NOTICE OF VIOLATION

On November 1, 2023, Energy Safety conducted an inspection of Bear Valley Electric Service, Inc.'s WMP initiatives in the vicinity of the city of Big Bear Lake, California. The inspection report is enclosed herewith. Energy safety found the following violation:

INSPECTION REPORT

Item4IA1Img1: View of tree growing within three feet of bare conductors.

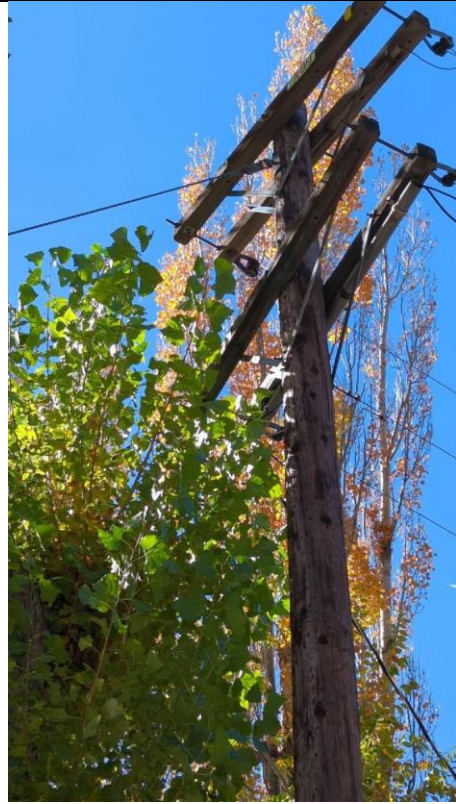
Near pole ID 3630BV at 41409 Park Avenue, Big Bear Lake, CA, 92315, USA, 34.2462367981346, -116.898800713462, the inspector observed vegetation growing within the 72-inch safe clearance distance under primary bare conductors. The inspector’s observation is documented in the Violation 1 photographs, which are attachments to this report. Photograph numbers Item4IA1Img1 and Item4IA1Img2 depict a tree growing approximately three feet under primary bare conductors.

1. The goal of Bear Valley Electric Service, Inc.’s Initiative 8.2.3.3 – Clearance is to proactively maintain vegetation so it does not contact electrical infrastructure, thereby preventing wildfires.
2. The tree is not in contact with bare conductor, but within Bear Valley Electric Service, Inc.’s minimum 72-inch safe clearance distance under bare conductors.
3. Bear Valley Electric Service, Inc.’s WMP clearance work was identified as complete at this location.

Item4IA1Img2: Secondary view of tree growing within six inches of crossarm and within three feet of bare conductors.
